CERTIFICATE OF APPROPRIATENESS

Property: 1301 Arlington Street, lot 12, tract 11B, block 168, Houston Heights Subdivision. The property includes a historic 2,643 square foot, one and half story wood frame single family residence and a detached two-story garage situated on a 7,788 square foot (59' x 132') corner lot.

Proposal: Alteration – Revision. Construct a balcony at the rear of approved addition. The balcony will be visible due to the corner condition of this property.

SOUTH SIDE ELEVATION FACING E. 13TH STREET
EXISTING

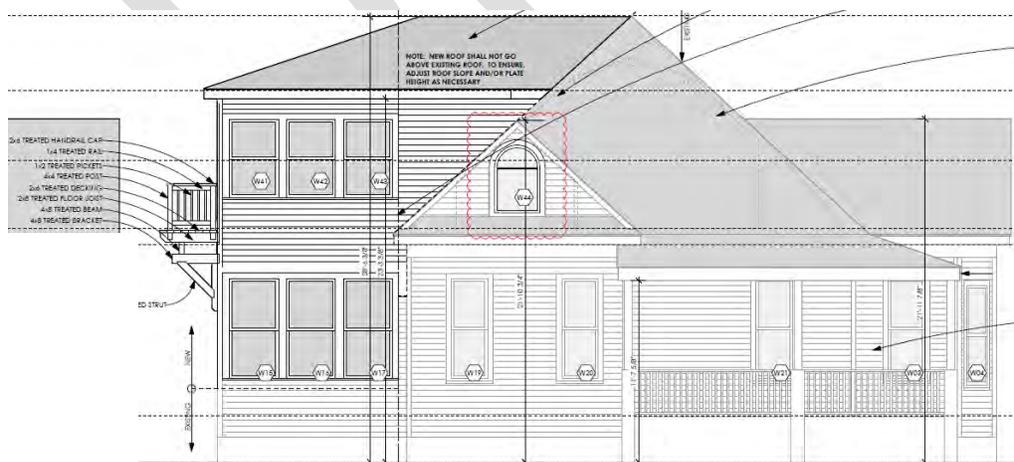
Due to an increase in eave and ridge height of the proposed addition, the eave of the addition now slightly extends past the existing roofline. The ridge height of the proposed addition now matches the existing ridge height. The proposed balcony will extend out from the rear of the second floor. See drawings for more detail.

NORTH SIDE ELEVATION

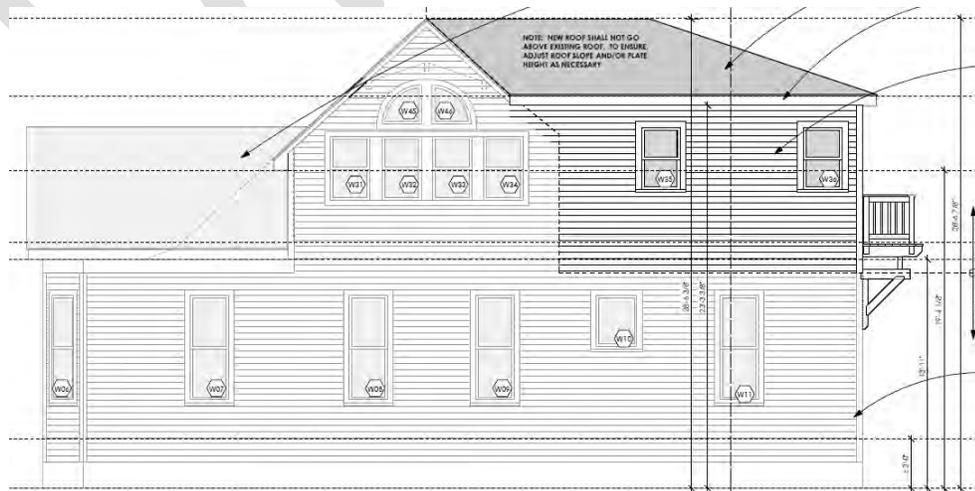
Due to an increase in eave and ridge height of the proposed addition, the eave of the addition now slightly extends past the existing roofline. The ridge height of the proposed addition now matches the existing ridge height. The proposed balcony will extend out from the rear of the second floor. See drawings for more detail.

WEST (REAR) ELEVATION
EXISTING

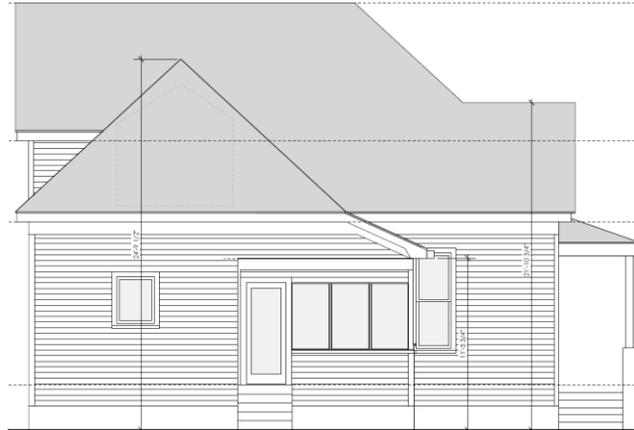
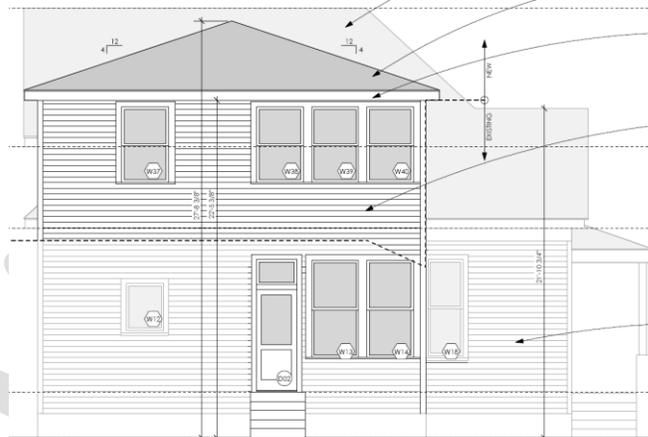
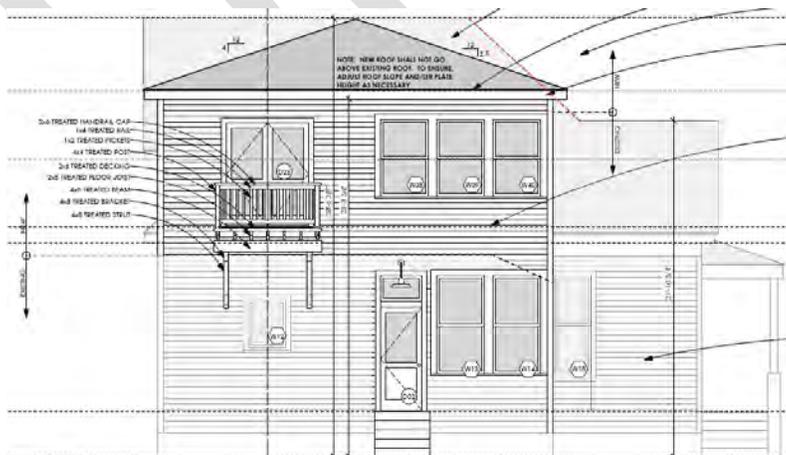
Due to an increase in eave and ridge height of the proposed addition, the eave of the addition now slightly extends past the existing roofline. The ridge height of the proposed addition now matches the existing ridge height. The proposed balcony will be located on the northern half of the second-story. It will be accessible by a French door. See drawings for more detail.

BALCONY DETAIL

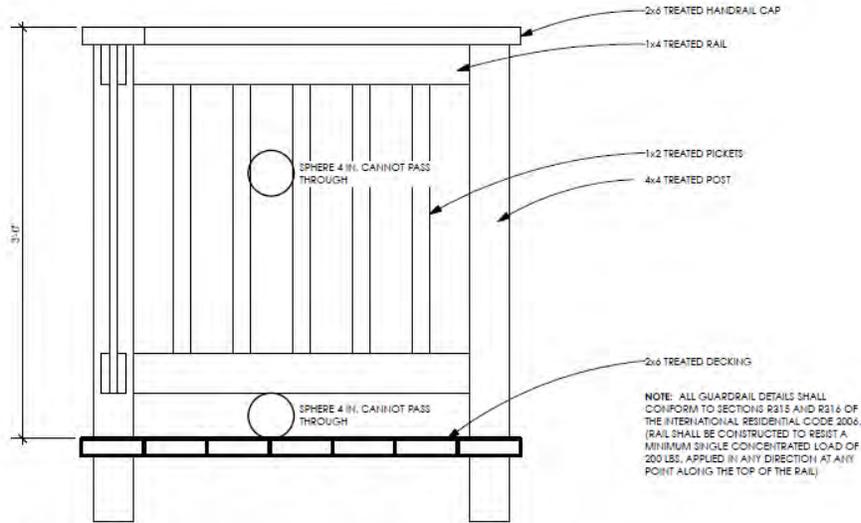
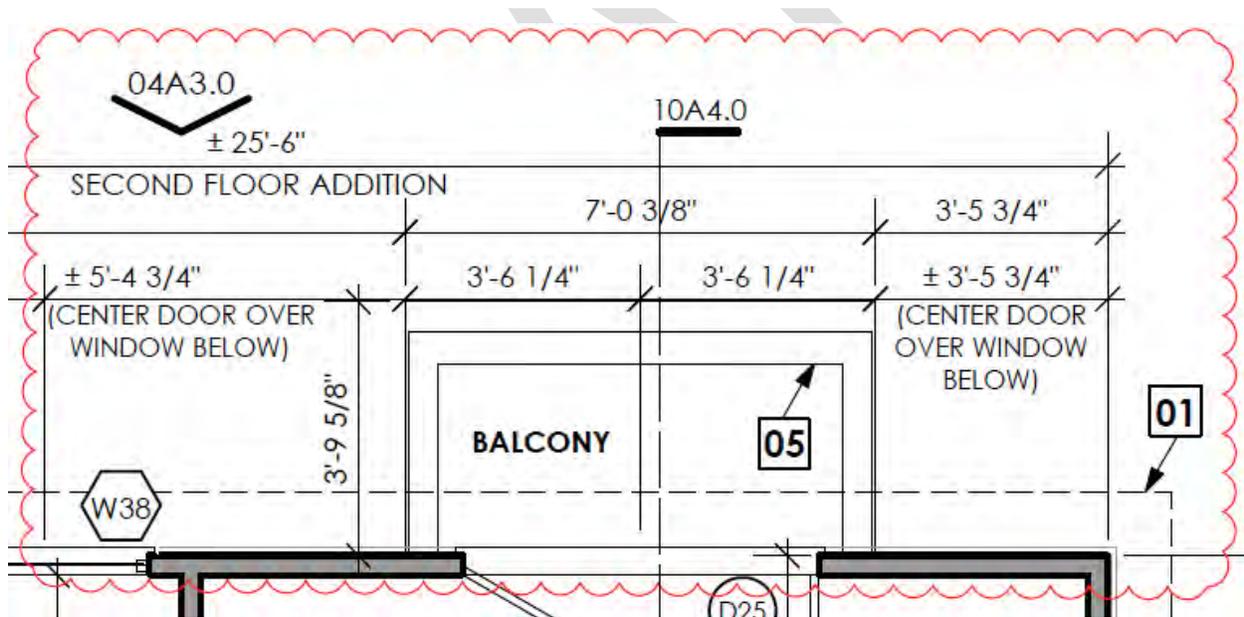
The proposed balcony will be constructed from treated wood. The balcony will be comprised of 2x6 treated handrail caps, 1x4 treated rails, 1x2 treated pickets, 4x4 treated posts, 2x6 treated decking. The balcony will be supported by 4x8 treated struts/brackets. See drawings for more detail.

SECOND FLOOR PLAN
PROPOSED

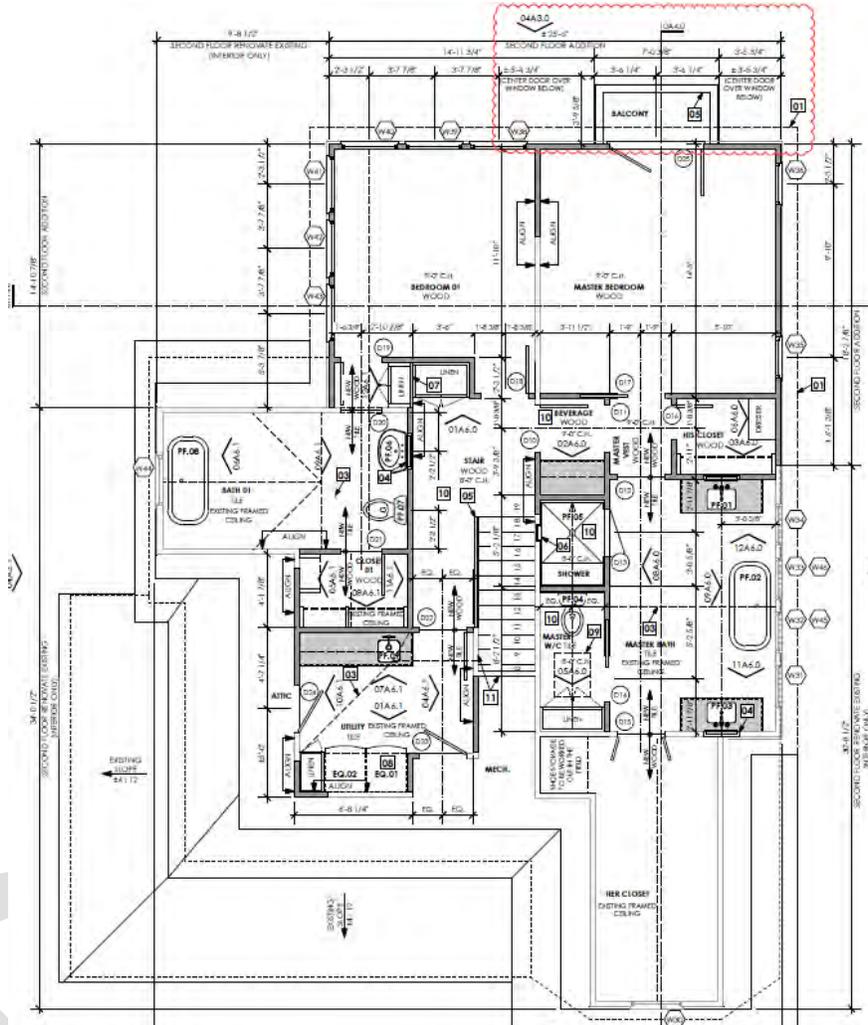
The proposed balcony will be located on the northern half of the rear addition, inset 3'-5 3/4" from the edge of the northern wall. The balcony will be 7'-0" wide, 3'-9 5/8" deep, and 3'-0" tall. The balcony floor will be installed 1 1/2" below the finished second-story floor. See drawings for more detail.

To access the proposed rear balcony, a 5'-4" wide by 6'-8" tall French door will be installed. See window/door schedule and drawings for more detail.
